**ATTACHMENT 4**  
**VALUE ENGINEERING REPORT**

SUBJECT: Implementation Decisions on Value Engineering Proposals for the Freeport Harbor Channel Improvement General Reevaluation Report, Freeport, Brazoria County, Texas.

# ***Preliminary Value Engineering Study Report***

## ***Freeport Harbor Channel Improvement Project GRR***

# VE ALTERNATIVE 1.1

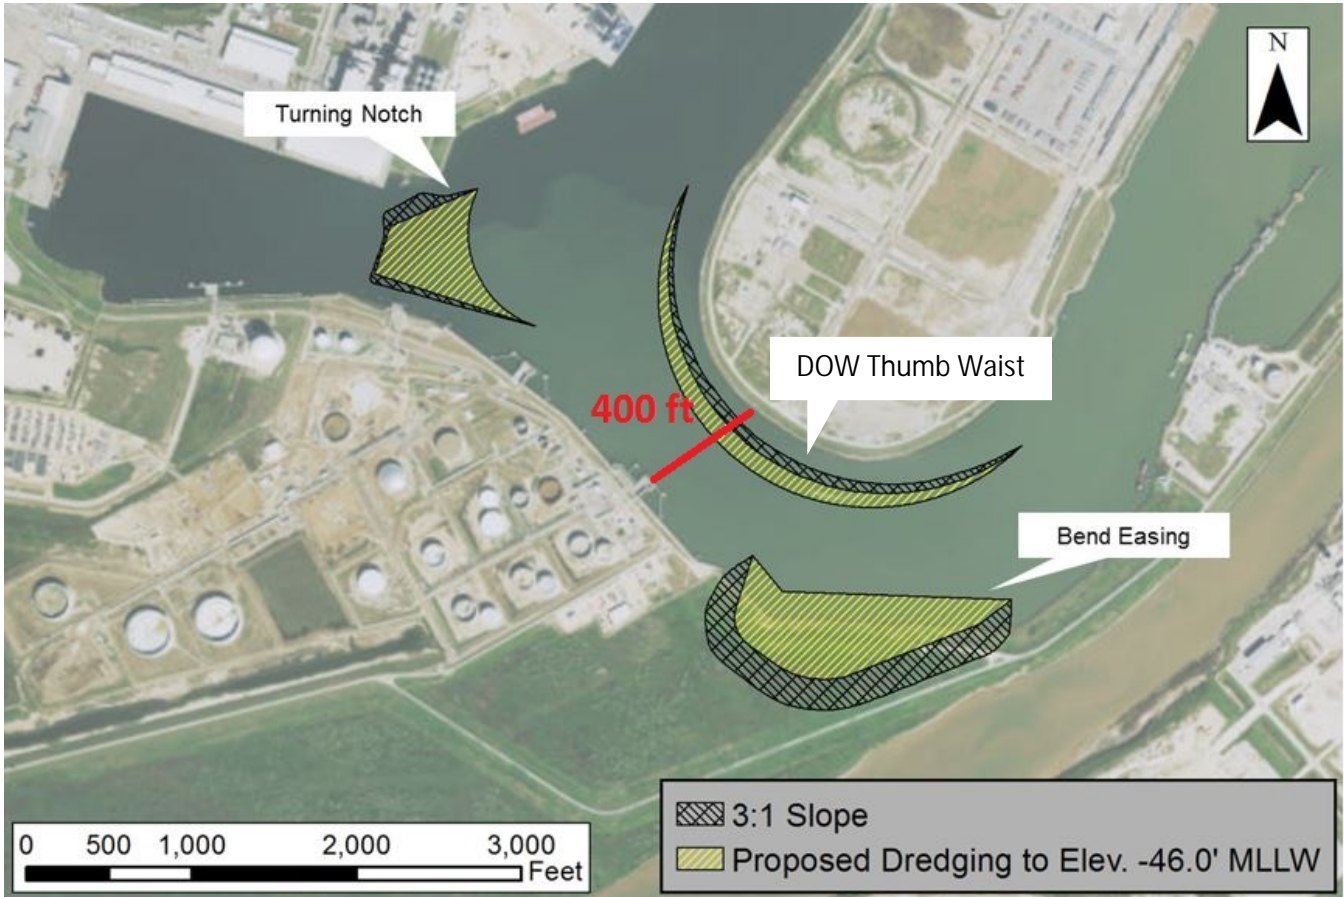
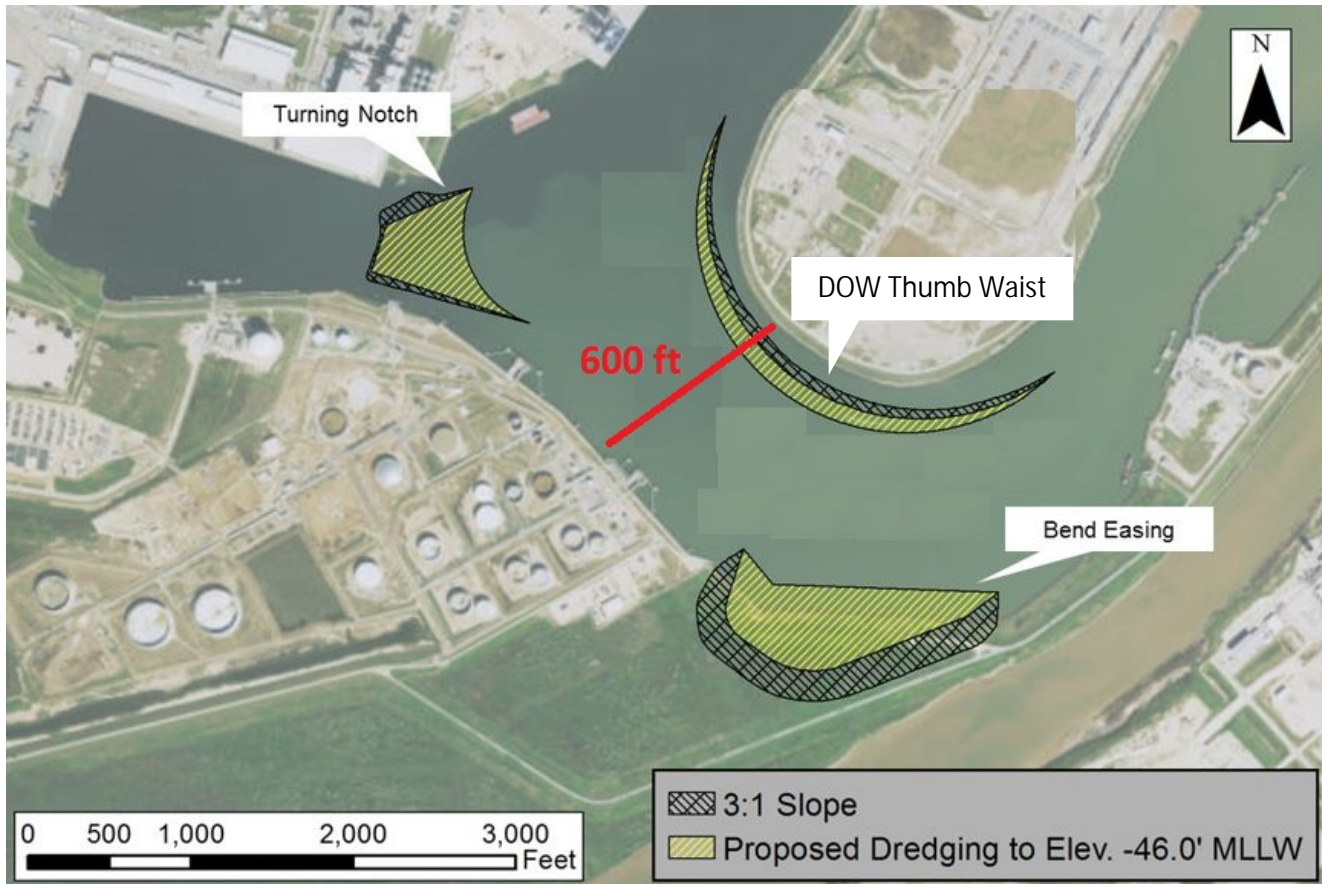
*The baseline concept proposes widening the section of the channel at DOW Thumb to 400 feet.*

#### VE Alternative Concept Sketch

## VE ALTERNATIVE 1.2

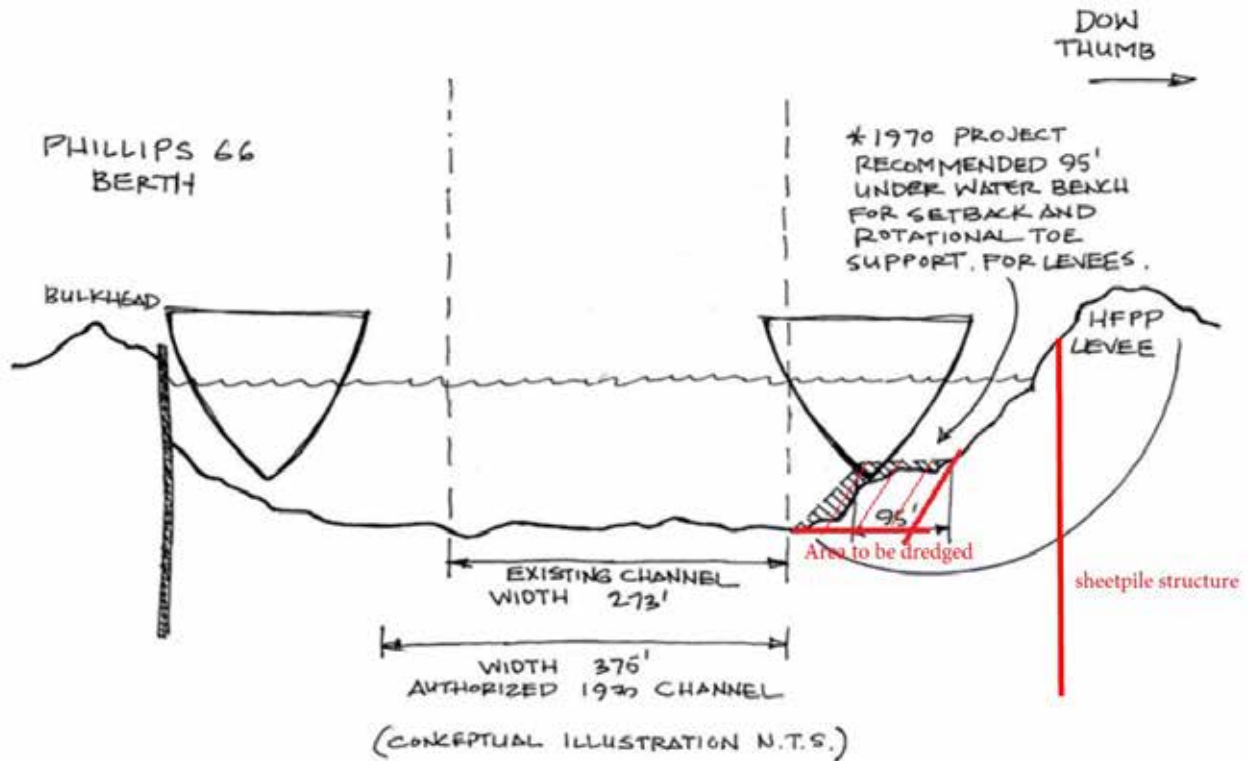
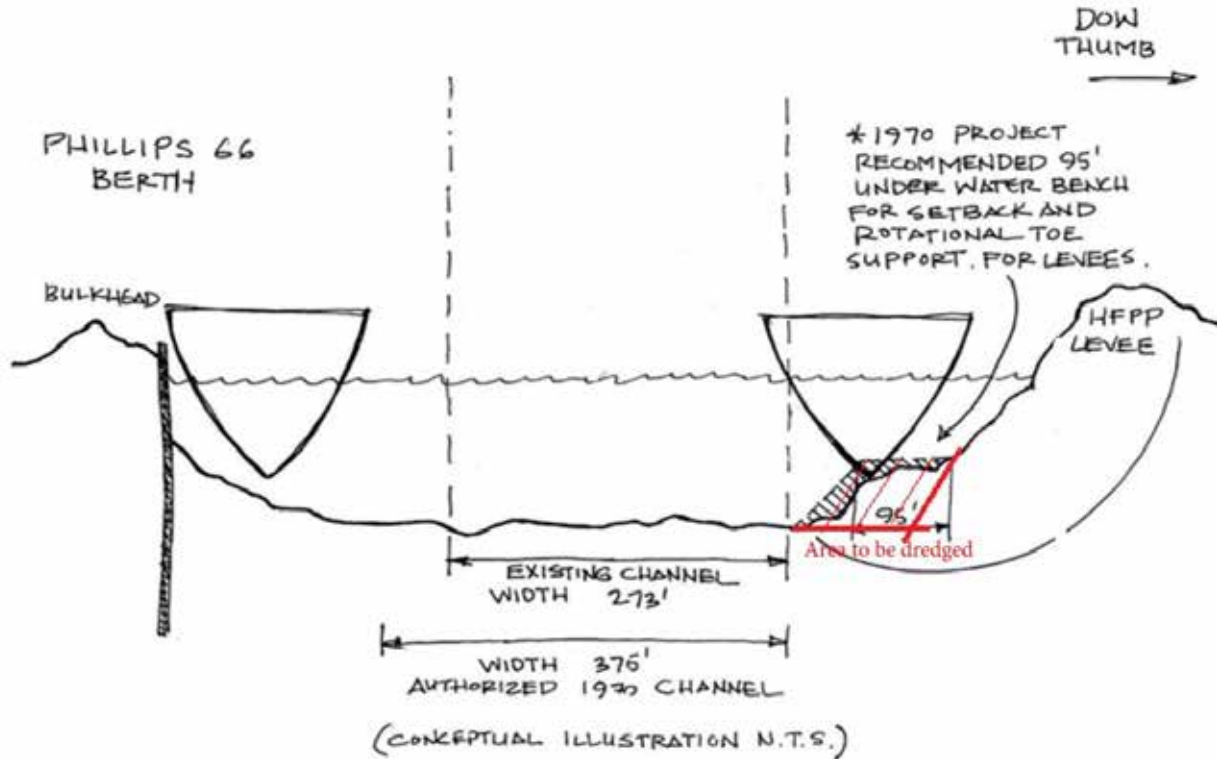
*The baseline concept includes installation of a sheet pile structure in order to mitigate for the effects of removing the existing underwater berm, indicated in the above sketch as "area to be dredged."*

The alternative proposes removing the underwater berm ("area to be dredged" above), but not installing a sheet pile structure.

## VE ALTERNATIVE 2.0

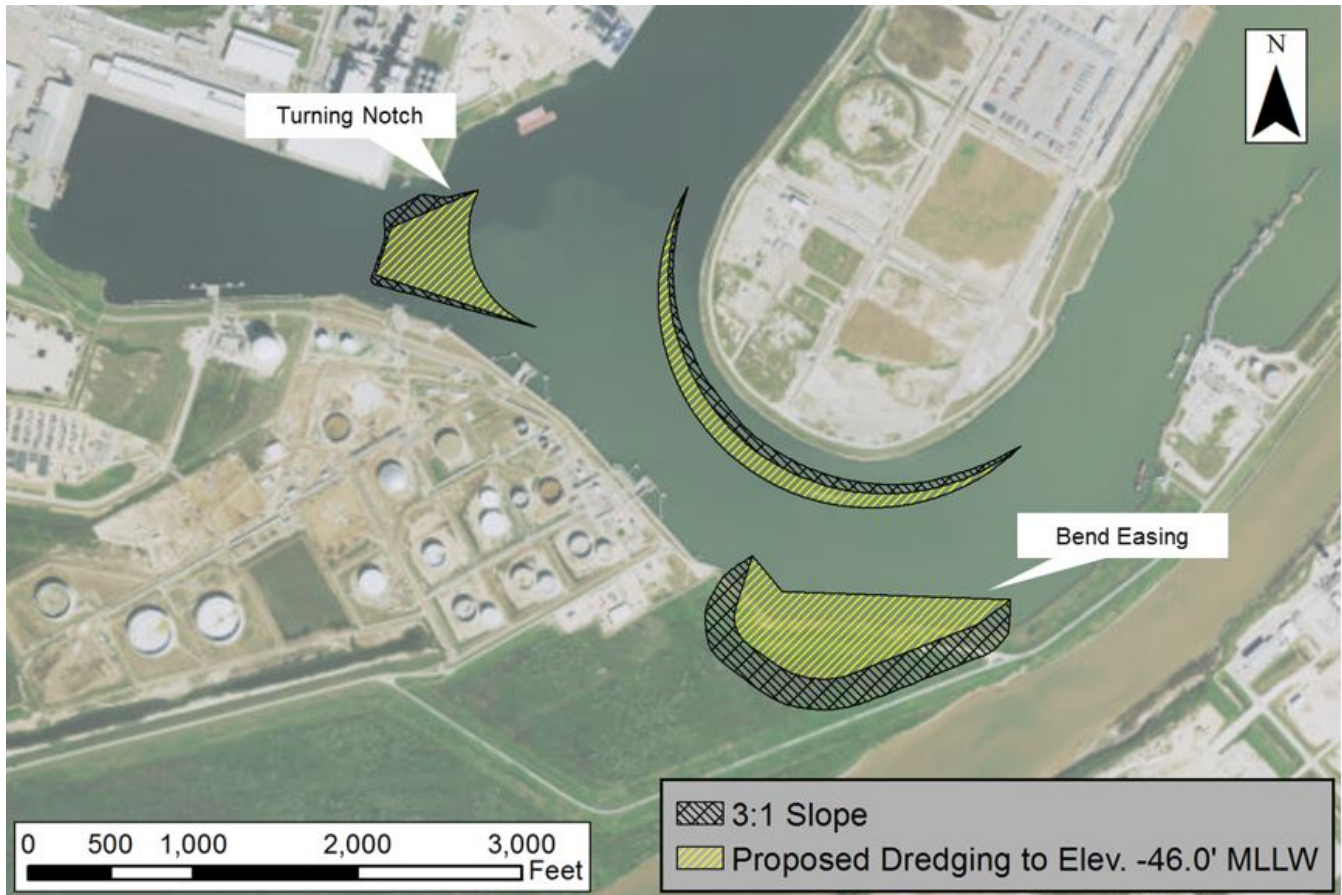
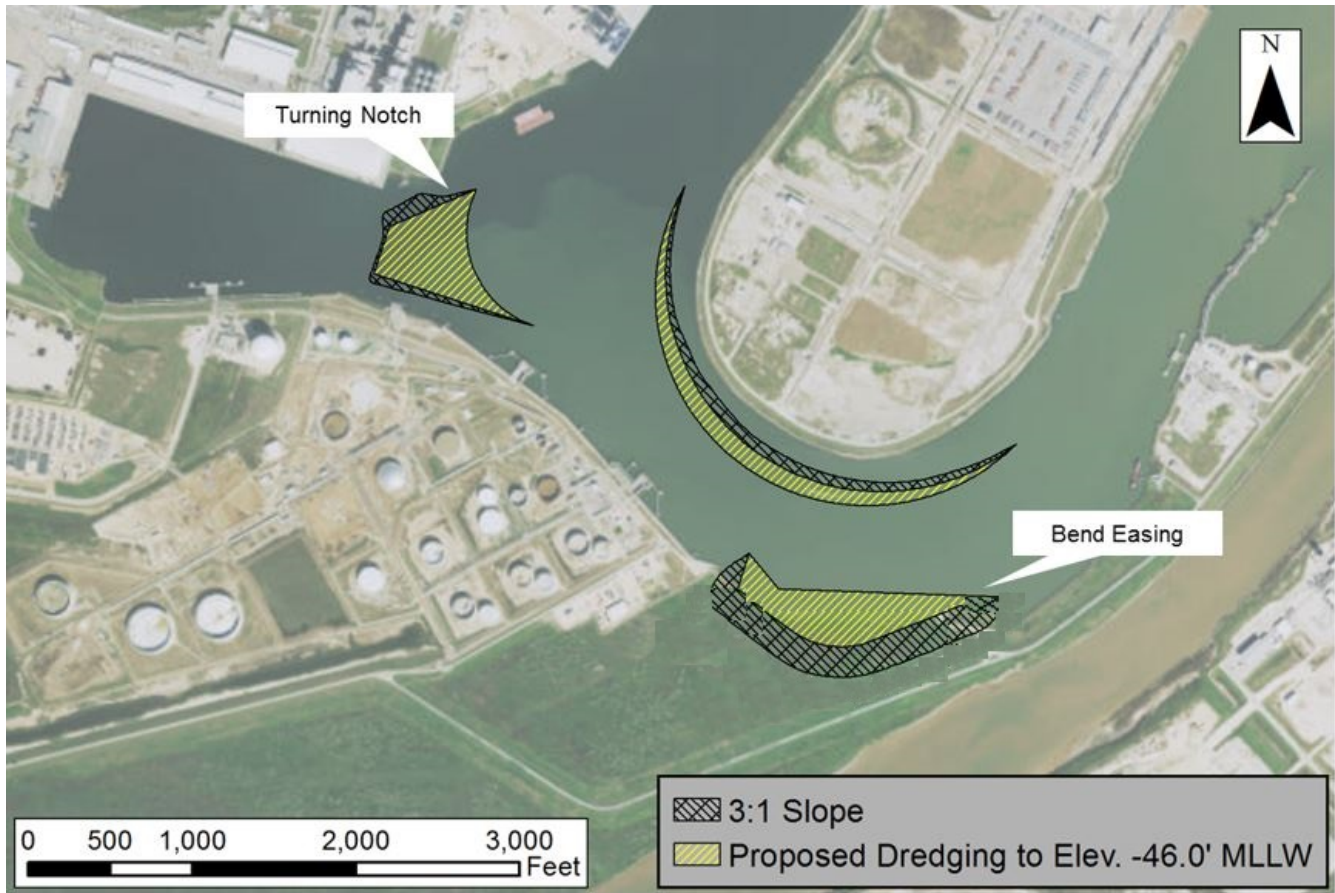
*The sketch above shows the area of the bend easing footprint as proposed in the baseline concept.*

The alternative would reduce the bend easing area by 20 percent, roughly shown in the sketch above. This assumes a reconfiguration of the bend easing area in order to provide optimal functionality despite the reduced footprint (not shown).

## VE ALTERNATIVE 3.0

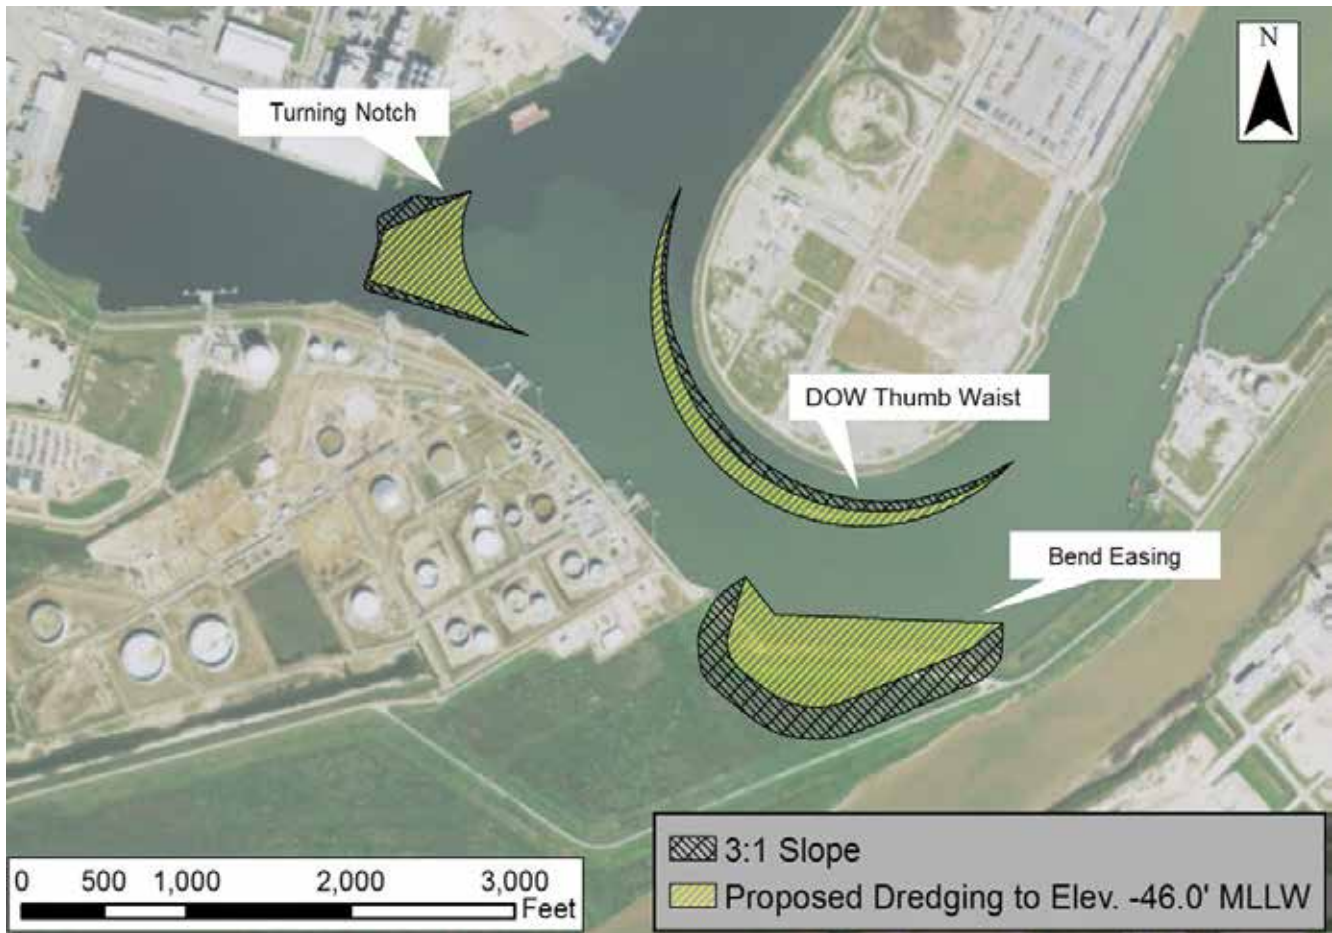
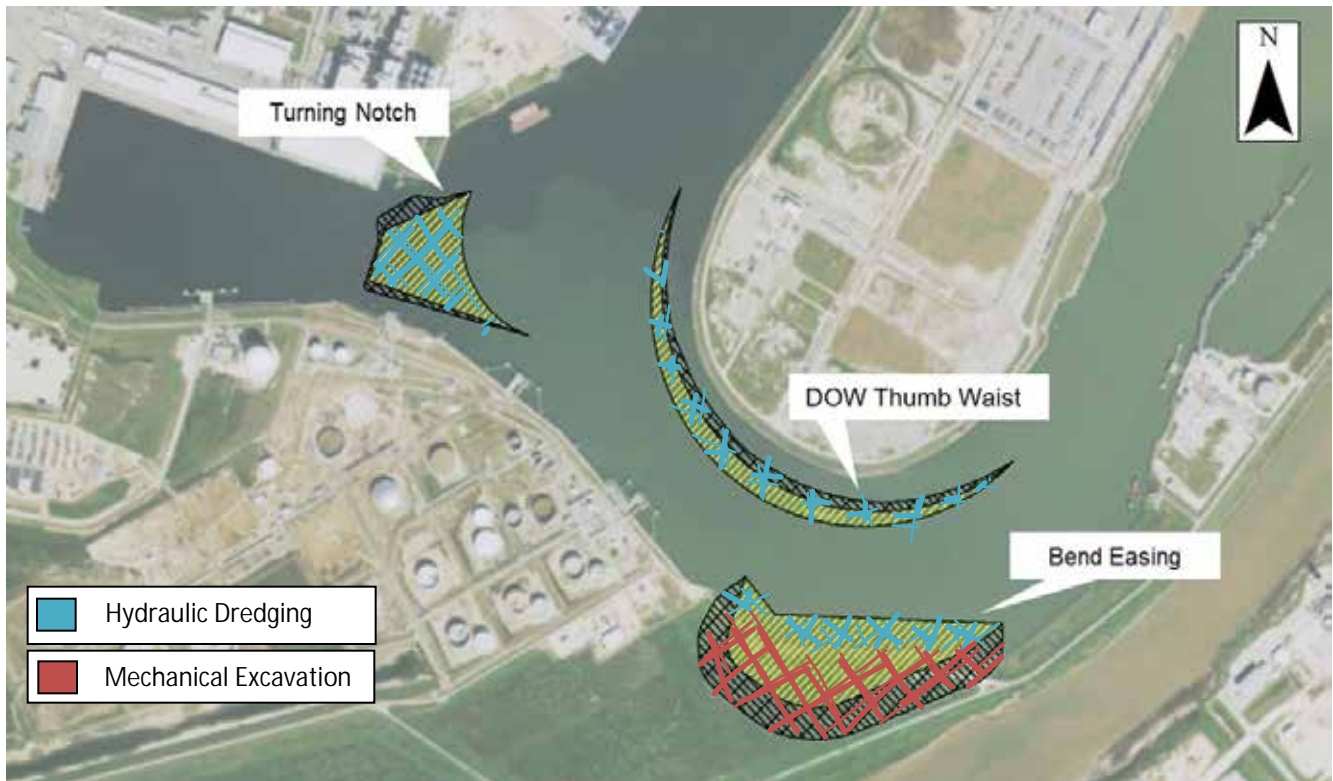
*The baseline concept assumes hydraulic dredging for the Turning Notch, DOW Thumb Waist and Bend Easing areas, shown above.*

#### VE Alternative Concept Sketches

VEP 3.0 recommends the use a combination of mechanical excavation and hydraulic dredging in lieu of only hydraulic dredging. The PDT is accepting this recommendation and has provided the TSP level cost estimate (Contract B) to reflect this incorporation. Note that the PDT is not considering defining the means and methods; therefore, allowing the contractor to determine the least cost method.

## VE ALTERNATIVE 5.0

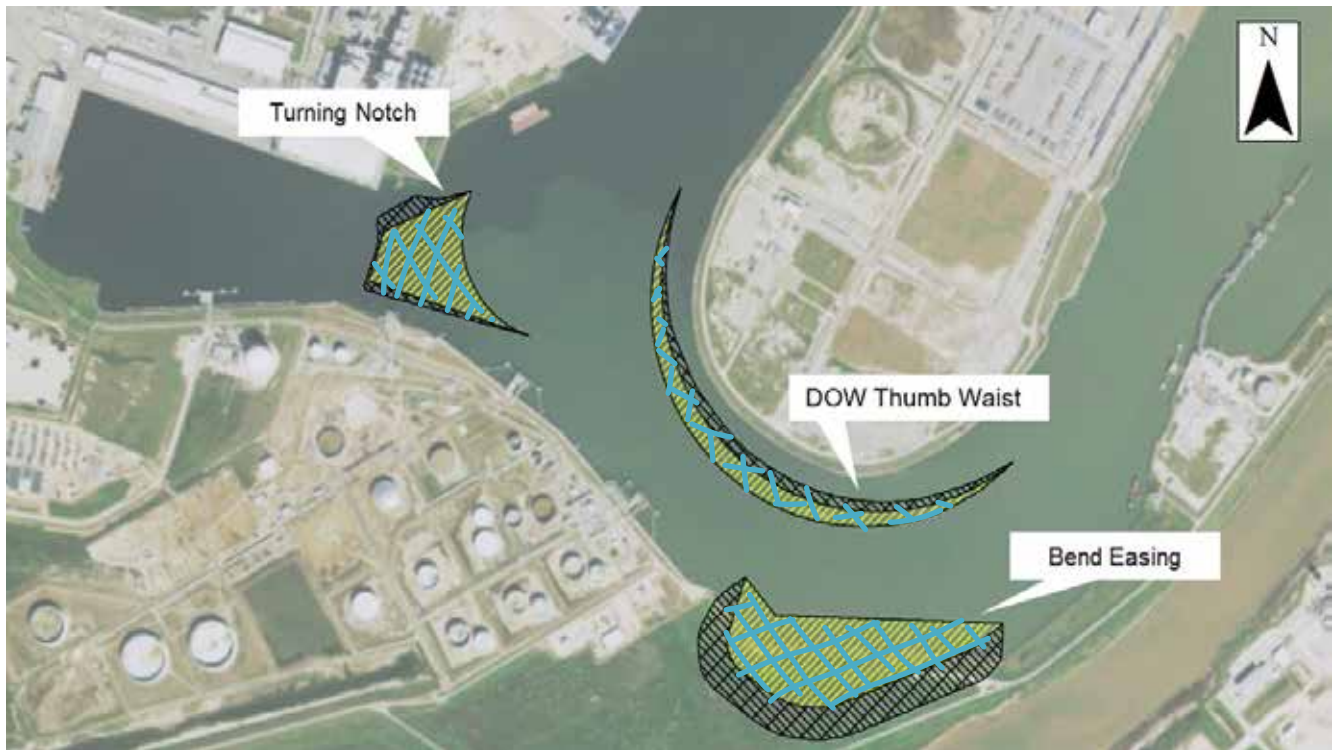
*The baseline includes 2 feet of advanced maintenance dredging in all areas shown in yellow above.*

### VE Alternative Concept Sketch
